## **3 Elm Row, London NW3: - Window Survey 7<sup>th</sup> May 2020, Rev: C**

### **Introduction**

### 3F-W1 – seating area – approx. 1900 x 1100mm

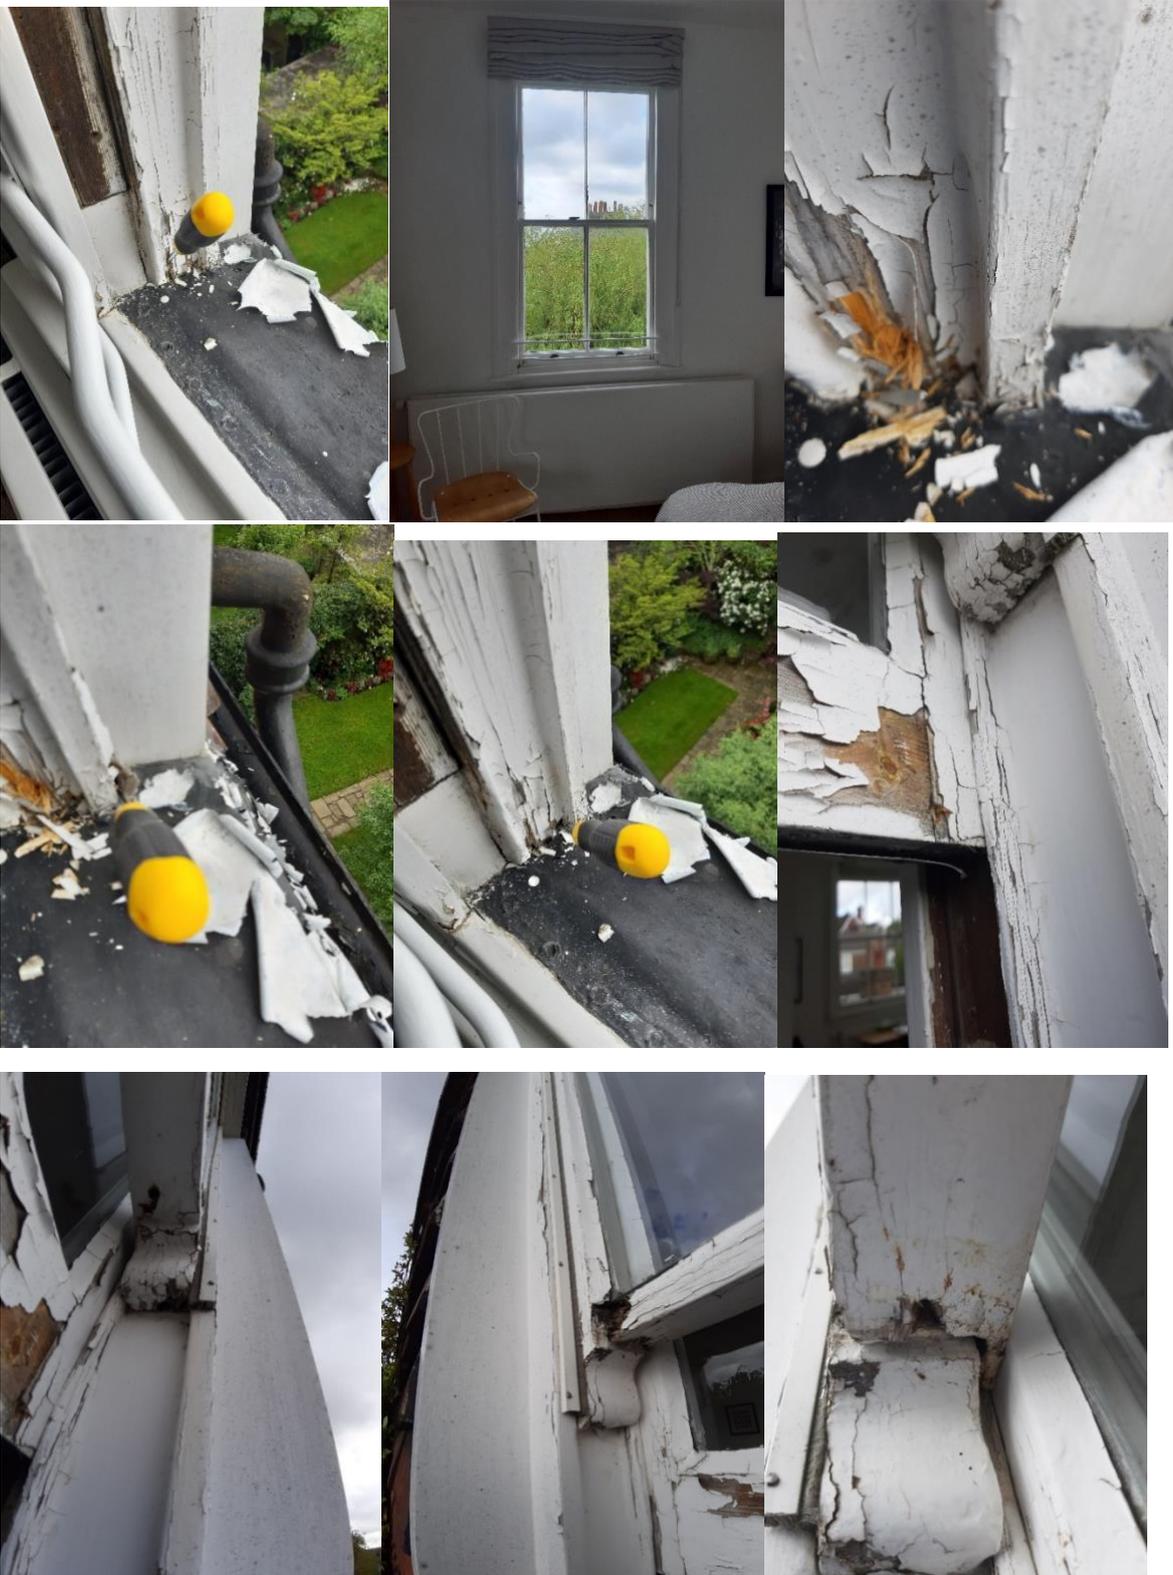
Box frame & sashes in a poor state with pulley stiles, outside lining & cill ends decaying. Was unable to see further along cill due to lead covering. Bottom sash bottom rail & stiles starting decay. Top sash meeting rail & bar decaying & separating due to tenon rotting.

Recommendation: - Replace sashes & parting beads, carry out repairs to lower section of box. Splice in new sections of pulley stiles, outside linings, inside linings, strip back lead from cill & repair as necessary.

**2F-W2 – Childs bedroom – approx. 1900 x 1100mm - arched head.**

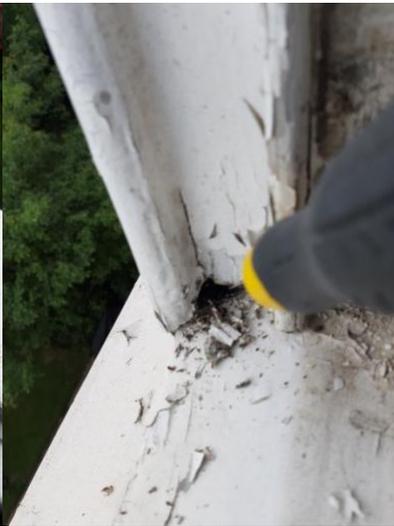
Cill, pulley stile & l/h outside lining have decay. Top sash meeting rail has repair brackets with decay under. Meeting rails do not meet. Head & outside head lining have decay.

Recommendation: - Replace sashes & parting beads, carry out repairs to lower section of box. Splice in new sections of pulley stiles, outside linings, inside linings. Repair cill as necessary.

### **2F-W4 – Guest bedroom – 1900 x 1100mm – arched lining**

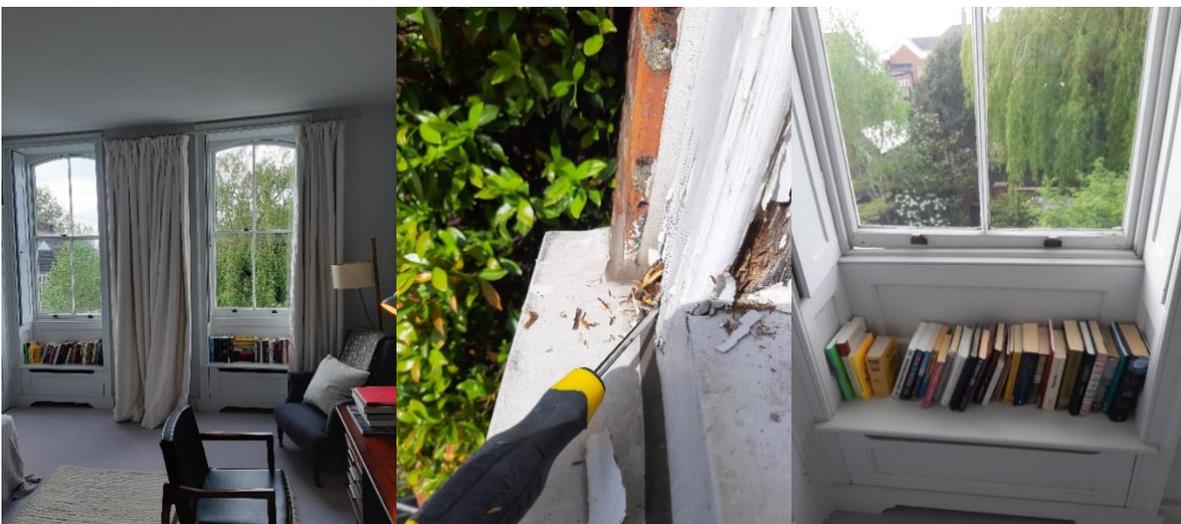
Pulley stiles & cill decay, outside lining decay above previous splice repair on both sides. Bottom sash bottom rail has decay at stiles and vertical bar, very poor fit at top and bottom due to previous subsidence, can see through to the outside, top sash meeting rail showing some decay behind previously installed repair brackets. Meeting rails do not meet.

Recommendation: - Replace sashes & parting beads, carry out repairs to lower section of box. Splice in new sections of pulley stiles, outside linings, inside linings. Repair cill as necessary.

### **1F-W5 – Master bedroom – approx. 2000 x 1100mm – arched head lining.**

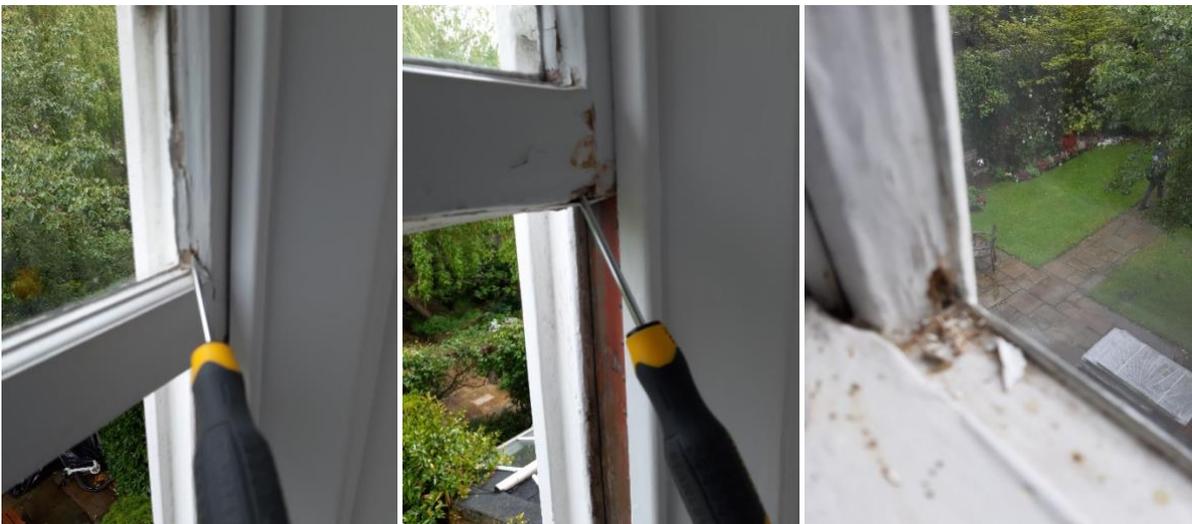
Decay to cill & pulley stile on left hand side. Decay to bottom sash bottom rail – replace. Signs of decay to top sash meeting rail.

Recommendation: - Replace sashes & parting beads, carry out repairs to lower section of box. Splice in new sections of pulley stiles, outside linings, inside linings. Repair cill as necessary.
